Albuquerque
Metropolitan
Arroyo
Flood
Control
Authority

Re: Journal Center Office Building, Tracts A2 & A3, ZAP D-17
Preliminary Plan Review

BRUNACINI JOURNAL CENTER

OFFICE BUILDING
TRACTS A2 & A3
ALBUQUERQUE, NEW MEXICO

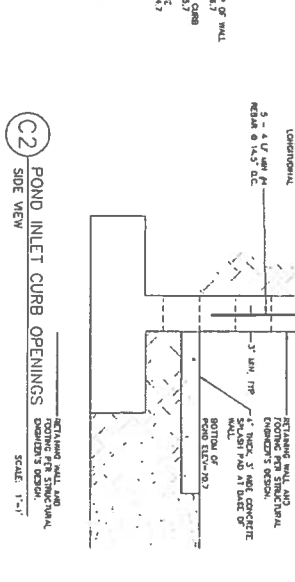
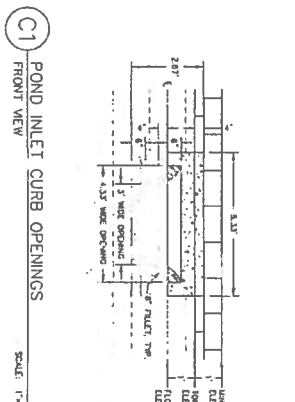
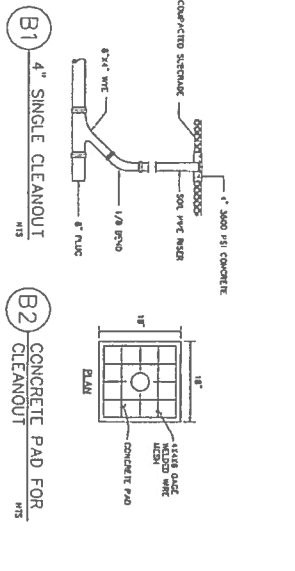
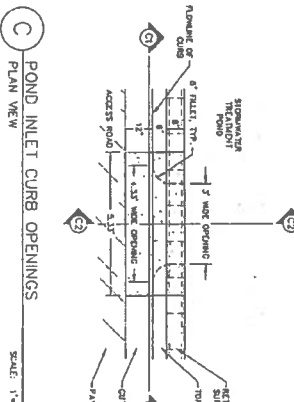
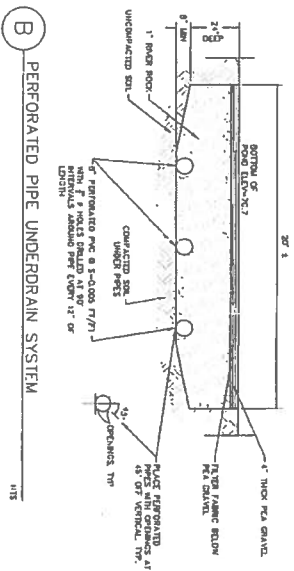
I reviewed the plan with respect to the water quality pond and outfall connection to the North Diversion Channel (NDC). Attached is the detail layout sheet with my mark-ups. I am not ready to approve the preliminary layout; I will need to see the site plan to determine the site drainage pattern. On the detail sheet, it appears that only the loading dock area and the internal access road drain to the water quality pond. The intent of the water quality treatment is to take the first flush rainfall over the entire site through the pond.

I discussed the status of the Essayons Boulevard project with the AMAFCA Executive Engineer, Jerry Lovato. The project is a few years out and has not been approved by the AMAFCA Board of Directors or the U.S. Army Corps of Engineers. Therefore, we will require a concrete rundown connection to the existing NDC rundown structure as you have shown on the plan. We will also require it to extend to the south to capture the flow in the existing side inlet channel.

mtg w/ Amafa

Amafa is willing to do the maintenance if the property owner feels to do so.

motion pump if needed is

provide justification for ~~the~~ pump

told her I need a public drainage easement and a Drainage Covenant prior to site plan approval AND we want a gravity solution - most likely pipe over San Juan Chan pipe

CALCULATIONS: Brunacini Journal Center : 0/2/10/11

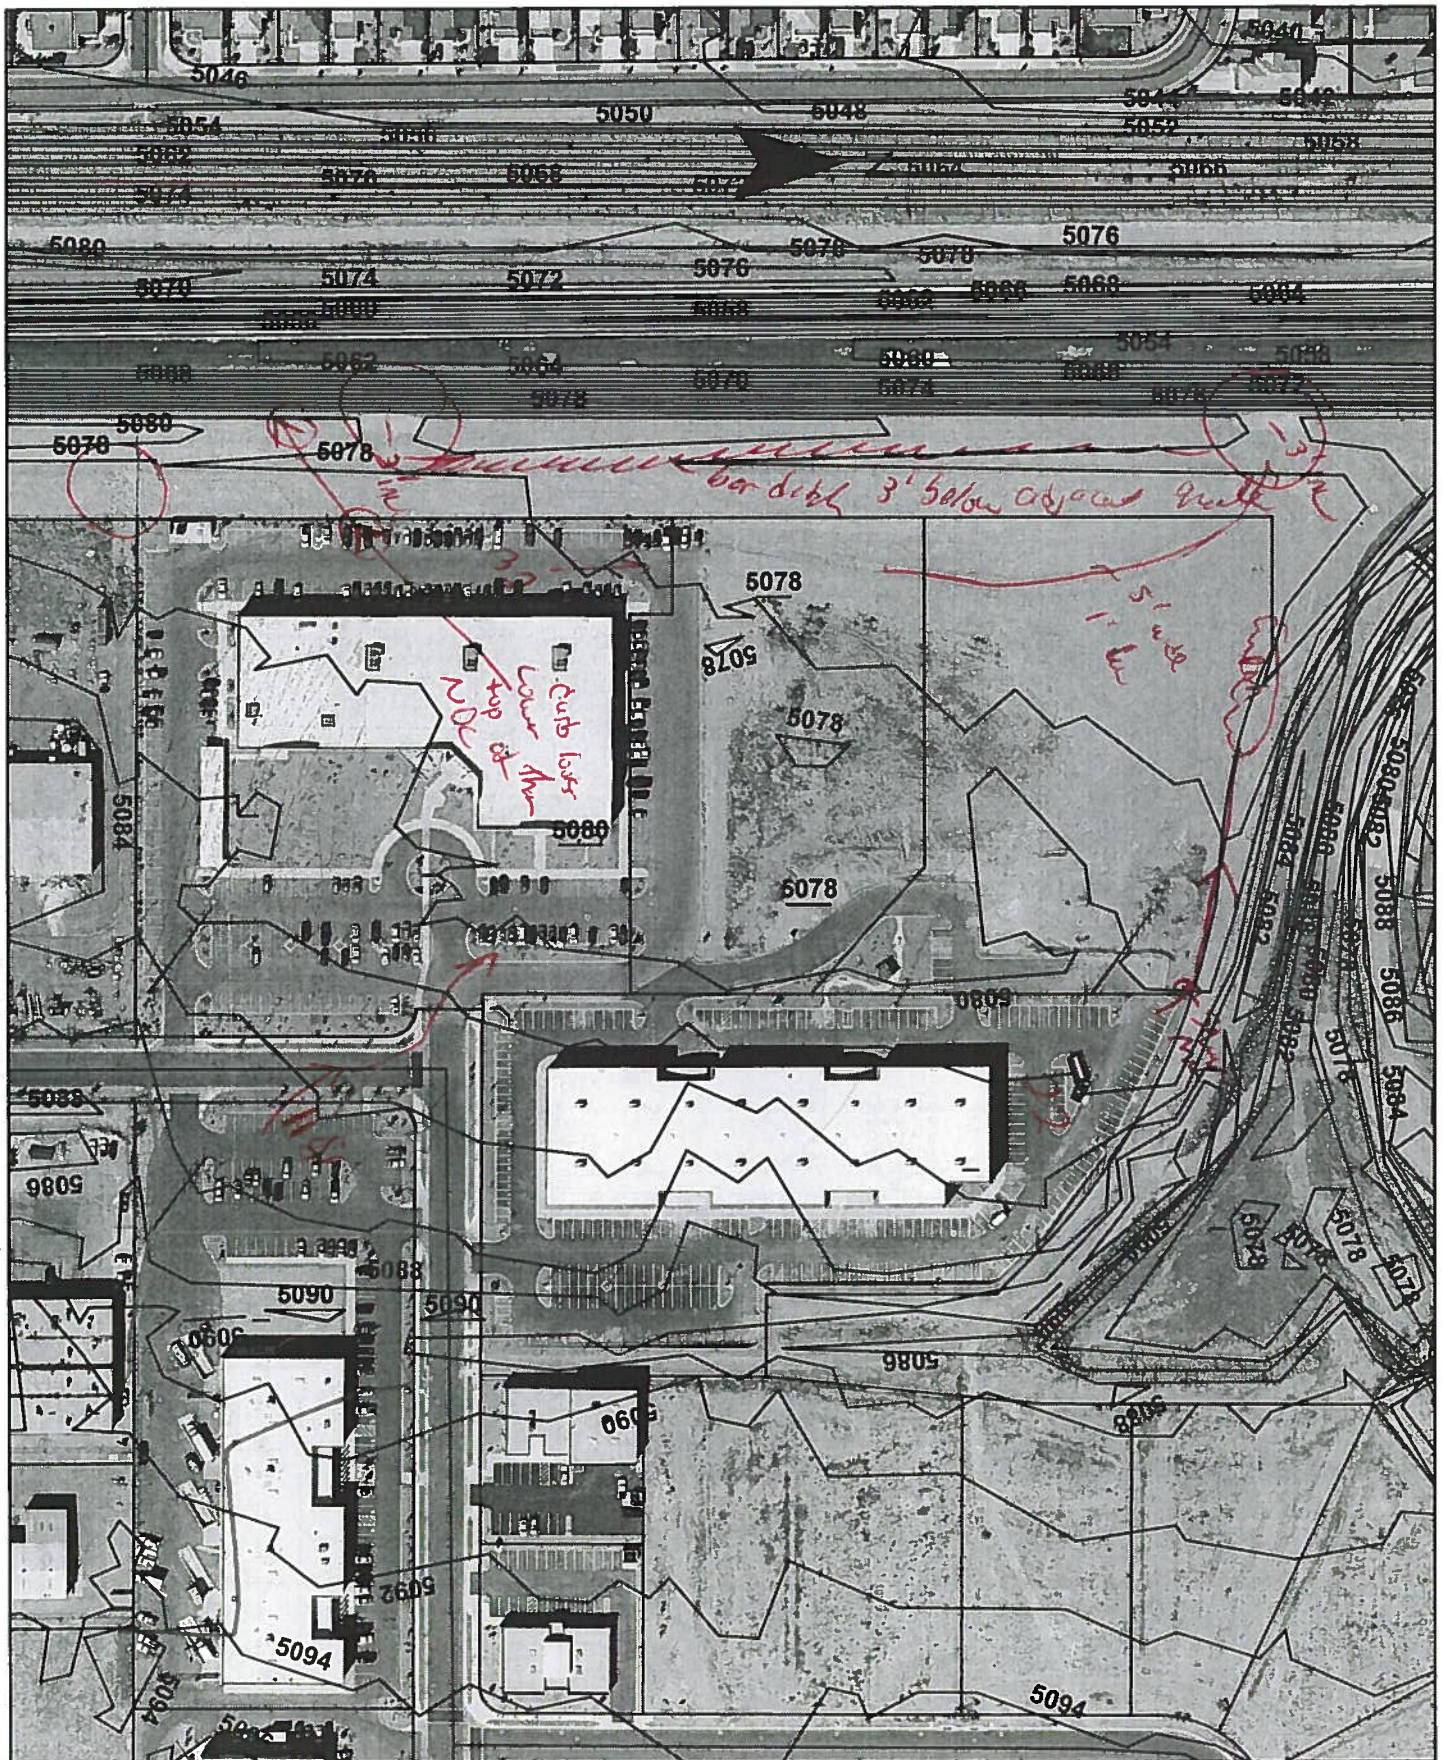
40' embankment
 covered in place
